**PROJECT MINUTES**

Project:	New W. Edward Balmer Elementary School	Project No.:	17020
Prepared by:	Joel Seeley	Meeting Date:	4/24/19
Re:	School Building Committee Meeting	Meeting No:	42
Location:	High School Media Center	Time:	6:30pm
Distribution:	School Building Committee Members, Attendees (MF)

# 36" STORM DRAIN LINE - SD DESIGN OPTION 1

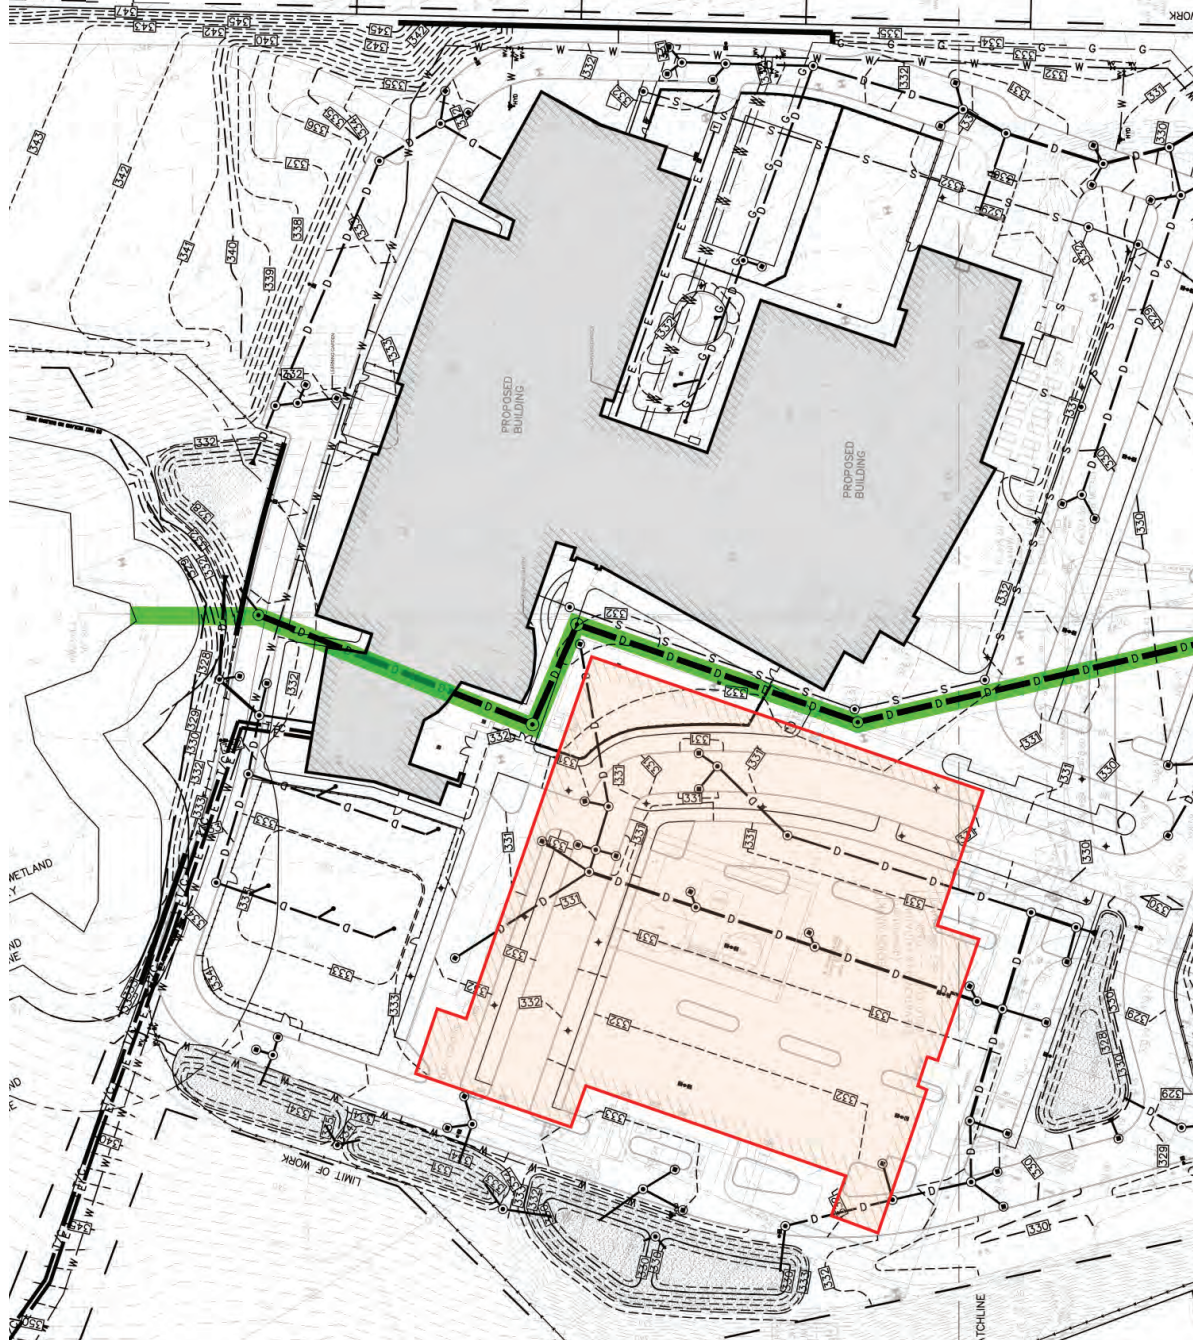
- Pipe shown as sketch to convey idea
- Rejected due to proximity and depth of excavation right next to existing building; would require shoring.
- Conflicts with new building foundations

# 36" STORM DRAIN LINE - SD DESIGN OPTION 1A

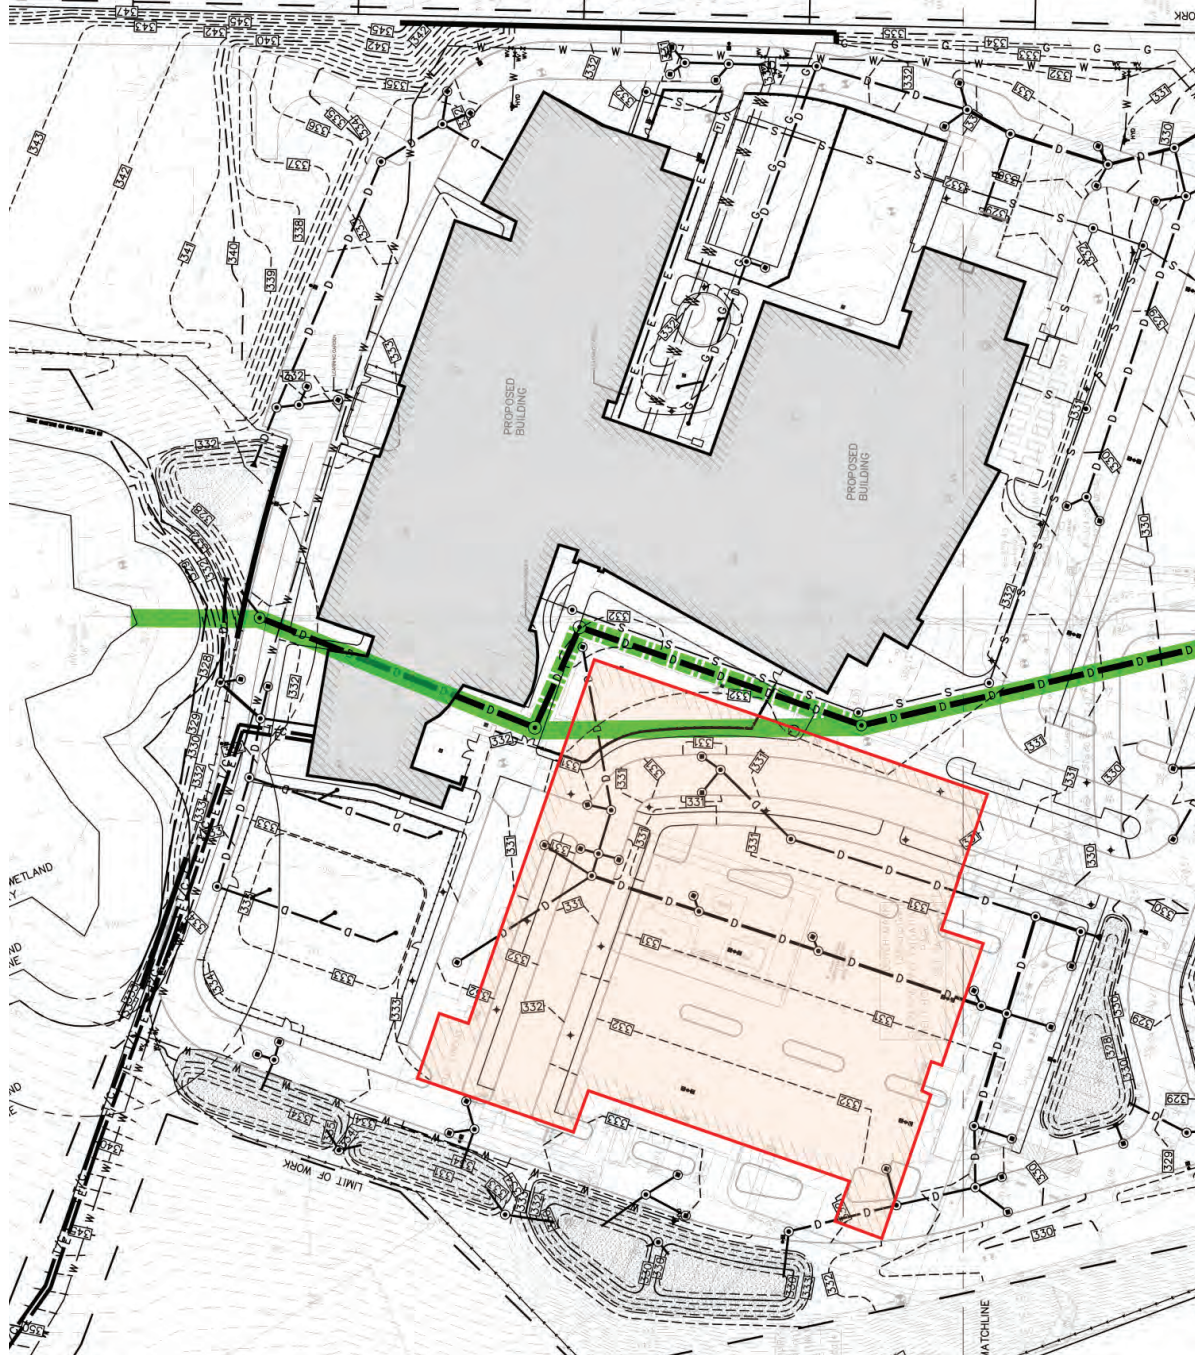
Step 1 - temporary drain  
during construction  
(dashed line)

Step 2 - Install permanent  
drain when existing building  
demo'ed

Sequence and depth of  
excavation did not work  
with summer schedule for  
bus lane going on-line for  
Fall 2021

# 36" STORM DRAIN LINE - DD DESIGN OPTION 2

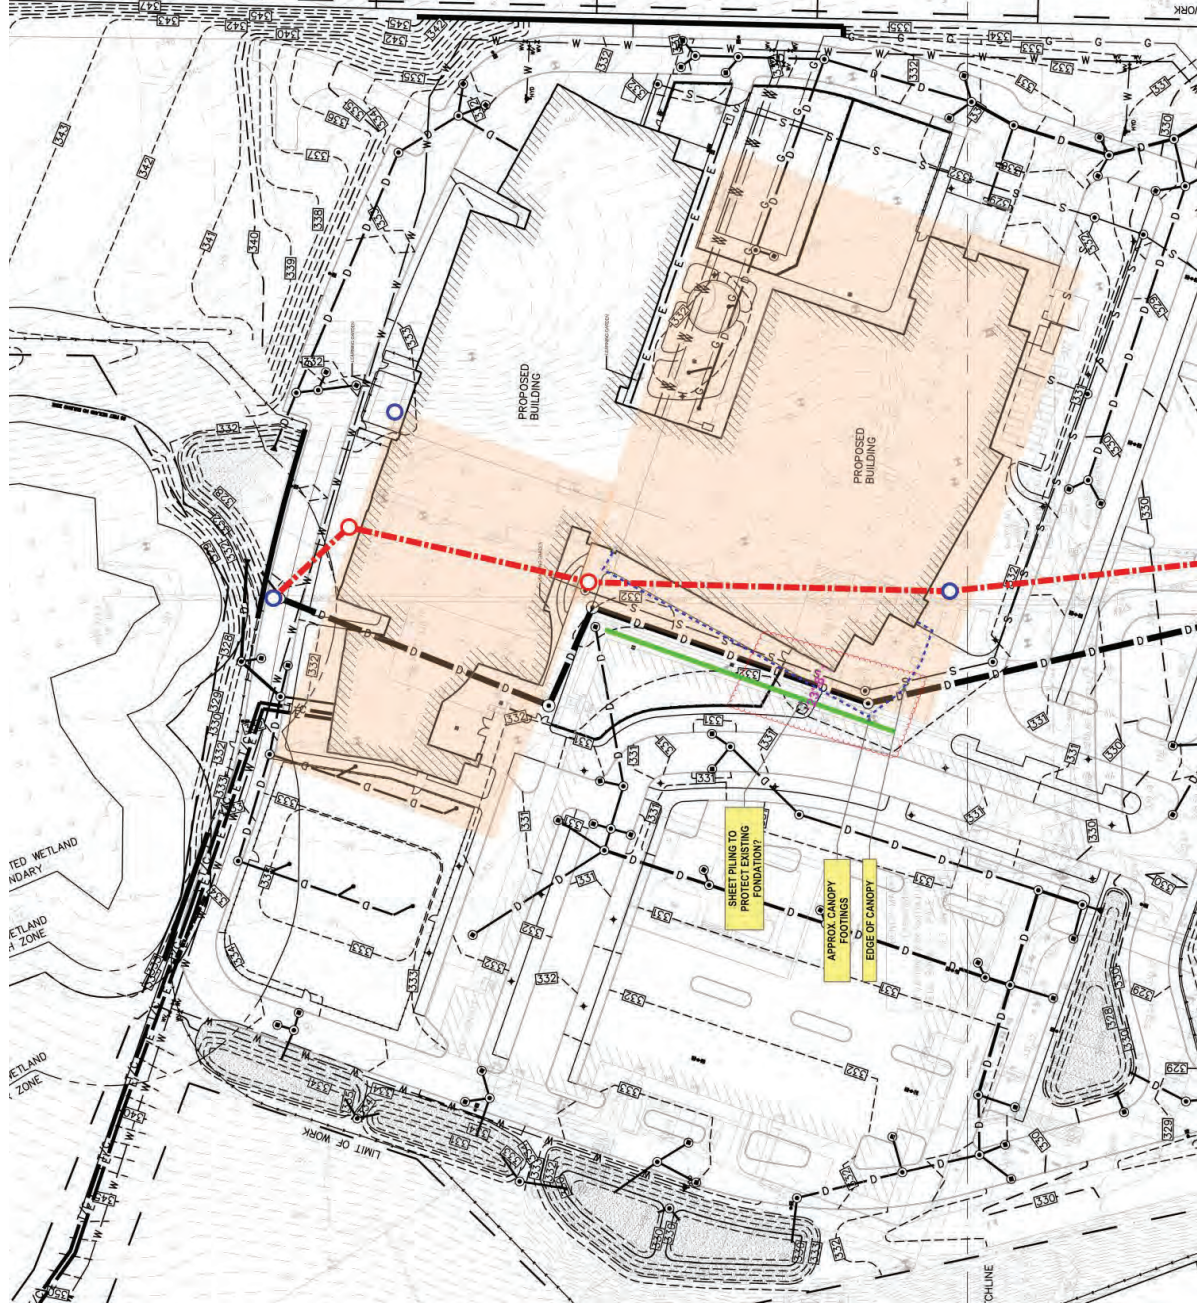
- Two-run drain pipe under A-Wing then C-Wing
- Rejected due to diagonal alignment to building geometry creating too much interference with foundations
- Also more beneficial for construction to be further away from the existing building

# VE UPDATE: ITEM # L03 CHAIN LINK FENCE

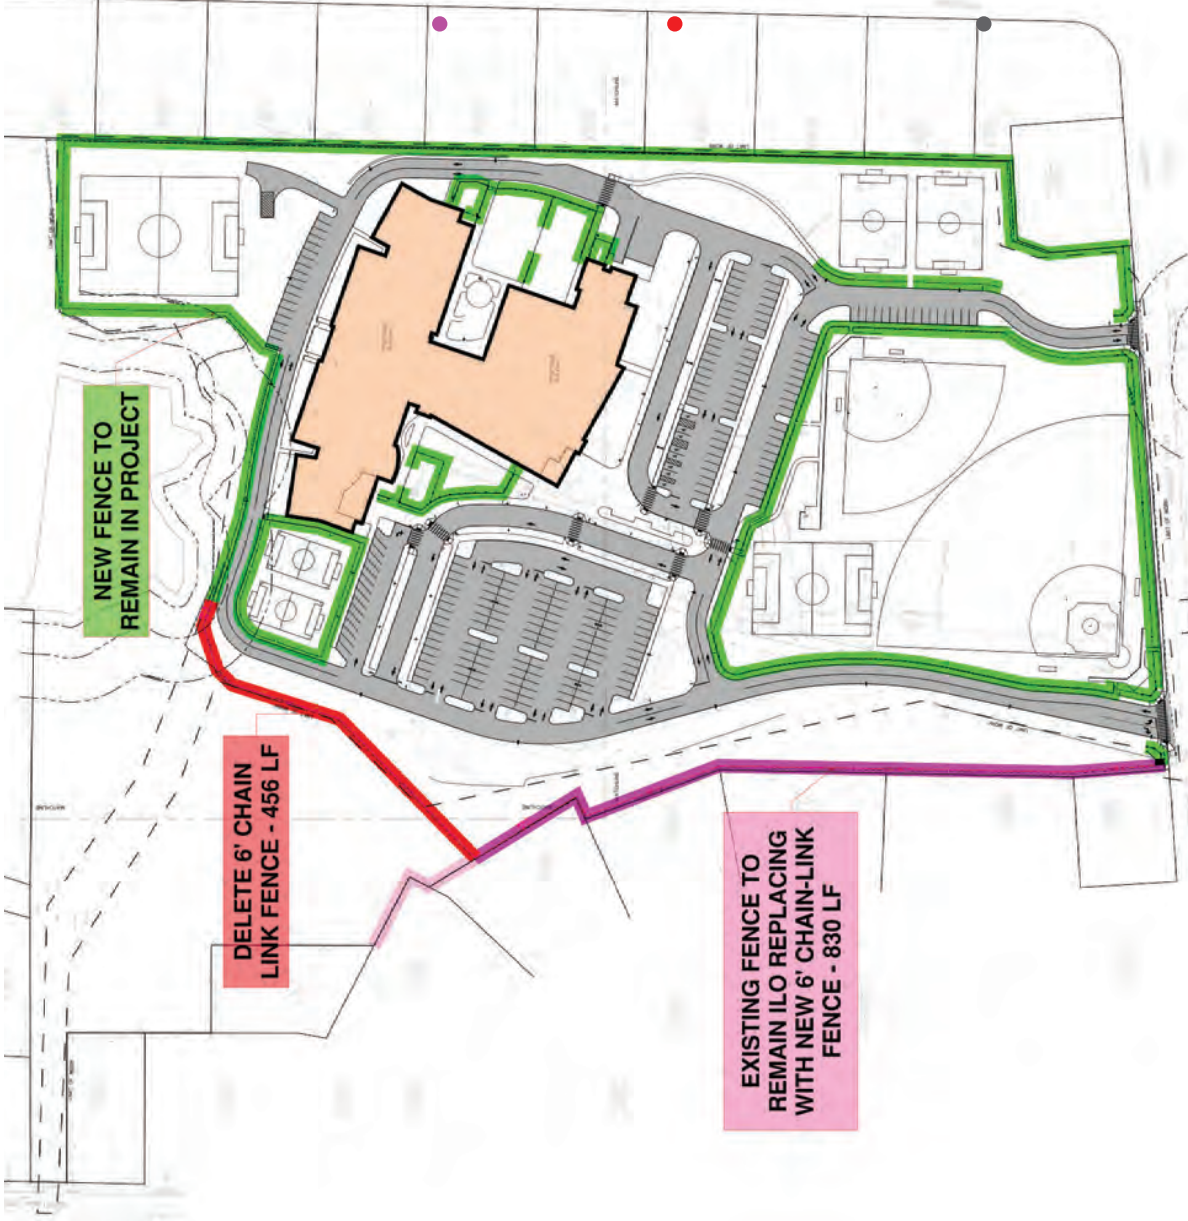
- West property line – existing 8' chain link fence to remain; repair any broken sections

- Delete segment of new fence that connects the west property line to the NW corner near wetland

**Option 1: Deduct (\$83,590)**

## #2 & 39 - TOILET ROOM PLAN – LAYOUT WITH ENTRANCE SPLIT

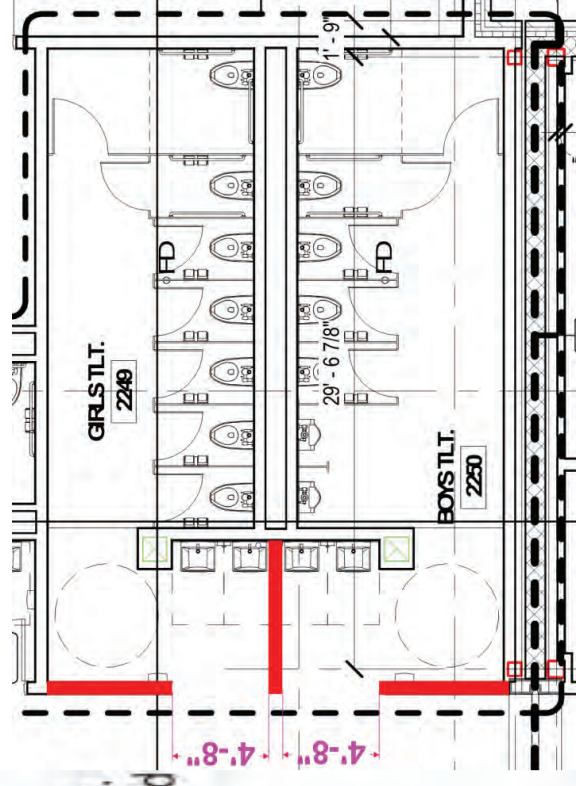
SBC requested divider partition at sinks (illustration)

Design Team Recommendation: Keep as designed.

## FAÇADE OPTION 1:

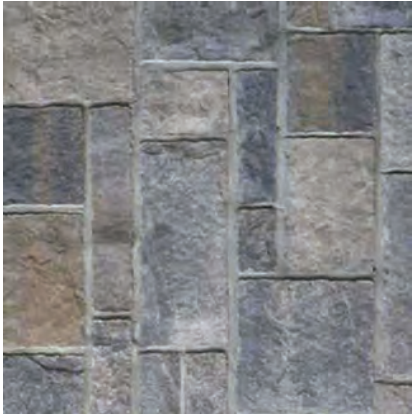
UTILITY BRICK (NOM 4 X 4 X 12"), "SHOULDICE" STONE-LOOK CMU BASE

Design Team Recommendation:  
Keep As designed

# VE LIST: ITEM 28

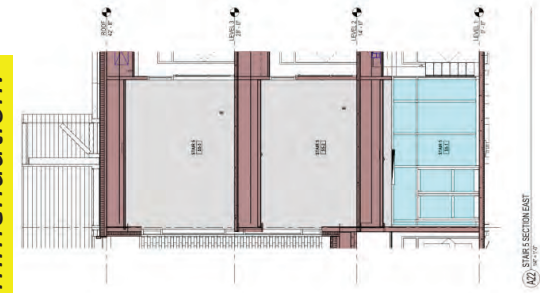
Item 28	Delete specified exterior mock-ups and go with in-place ILO	(\$41,000)
---------	---	------------

D&W and Fontaine Bros Recommend Stand-Alone Mock Ups

**Design Team Recommendation:  
Keep As designed**

STAIR 5 ENCLOSURE  
(AS DESIGNED)

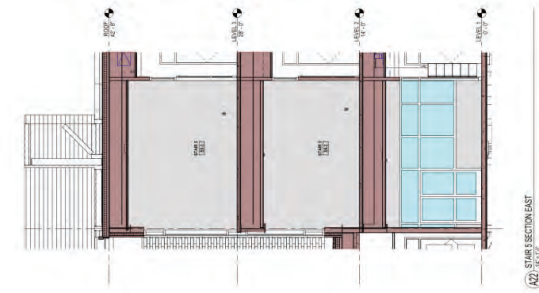
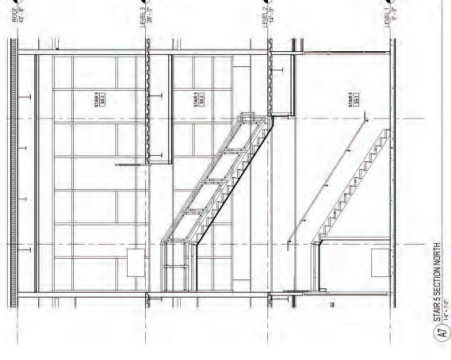
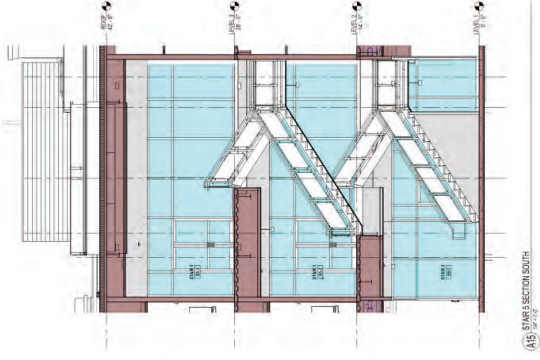
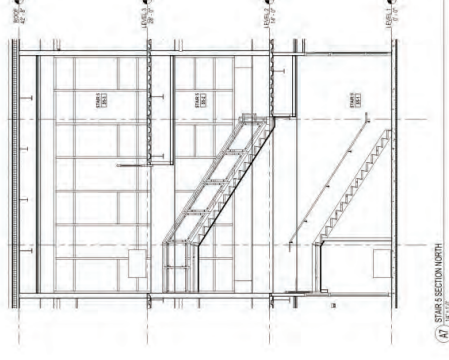
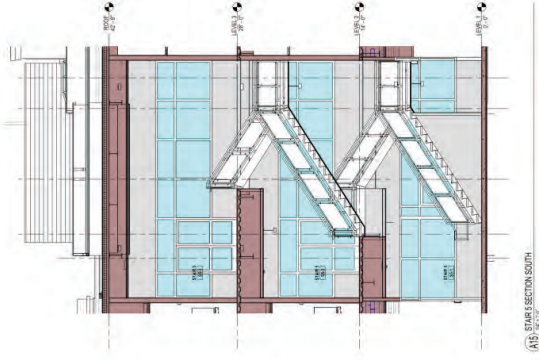
- Stair 5 transparency is central design element
- Main communicating stair for full population
- Lightwell at top to disseminate light through deep floor plate – all levels
- Full view to areas of refuge in case of fire
